# LDPC Parity Code Matrix Update for Improved Alignment (rev 1a)

5 March 2018 IEEE 802.3 Plenary, Chicago, IL, USA

# AWGN Performance

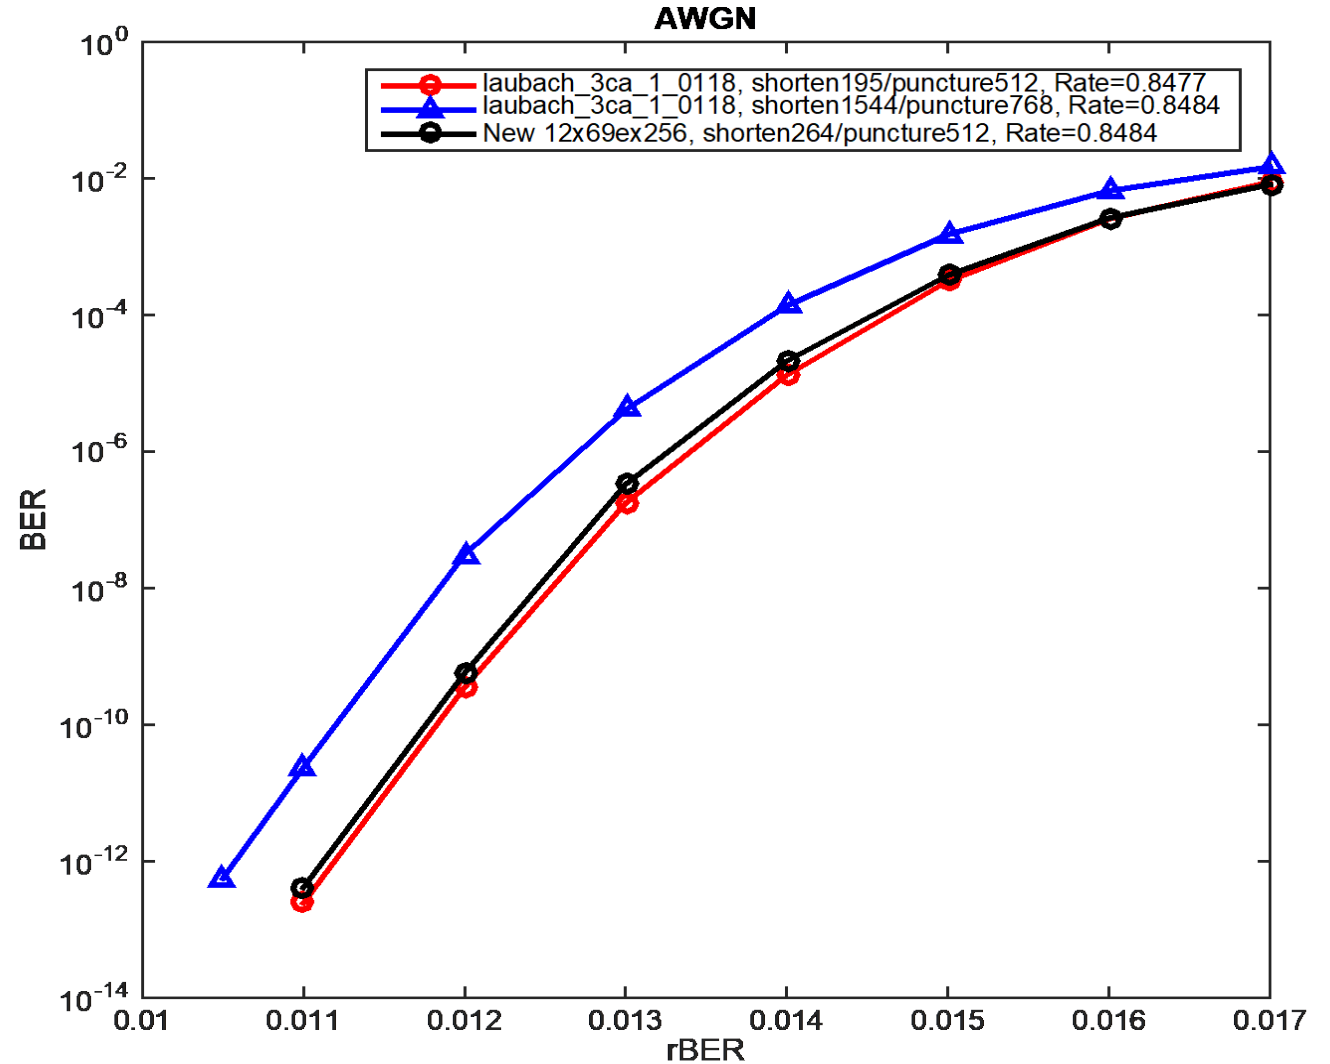
- Option 1: puncturing and shortening
  - Puncturing: 512 bits -> 768 bits
  - Shortening: 195 bits -> 1544 bits
  - Reduces gain by 0.08 dB
  - Rate 0.8477 -> 0.8484 (minor change)
- Option 2: new matrix [12x69ex256]
  - Puncturing: 512 bits
  - Shortening: 264 bits
  - Reduces gain by ~~0.022~~ 0.012 dB
  - Rate 0.8477 -> 0.8484 (minor change)

Rev a: updated plot

# Gilbert Burst Model Performance

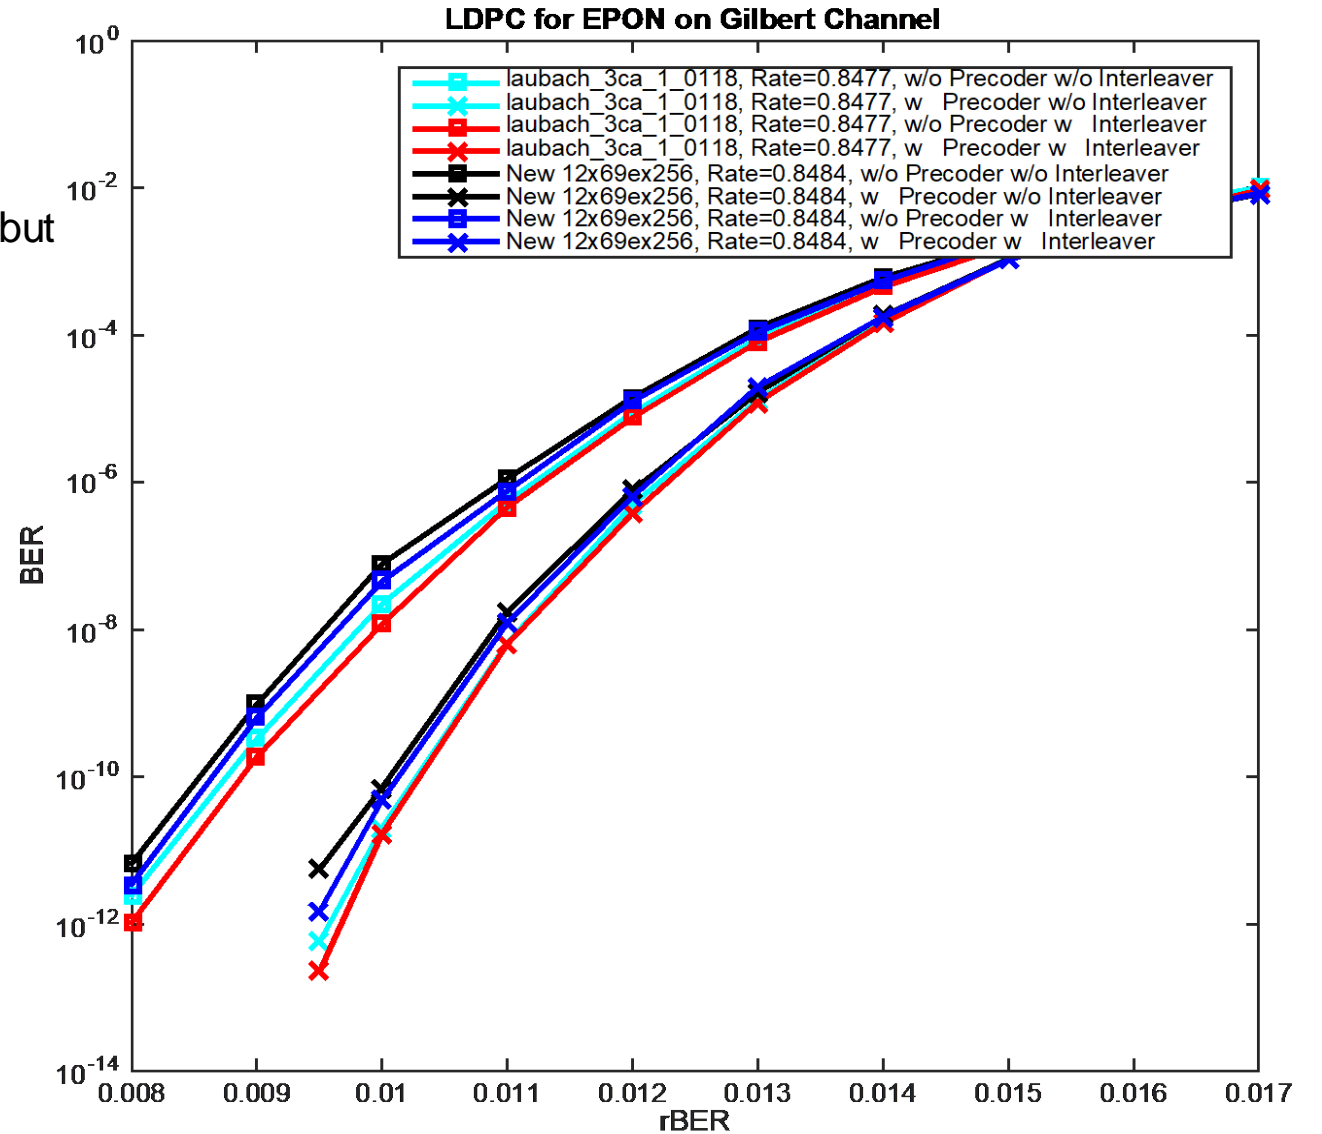
- For the “New” matrix, the previously adopted Omega256 interleaver is used in these simulation, but with an updated seed file.

Rev 1a: updated entire slide.
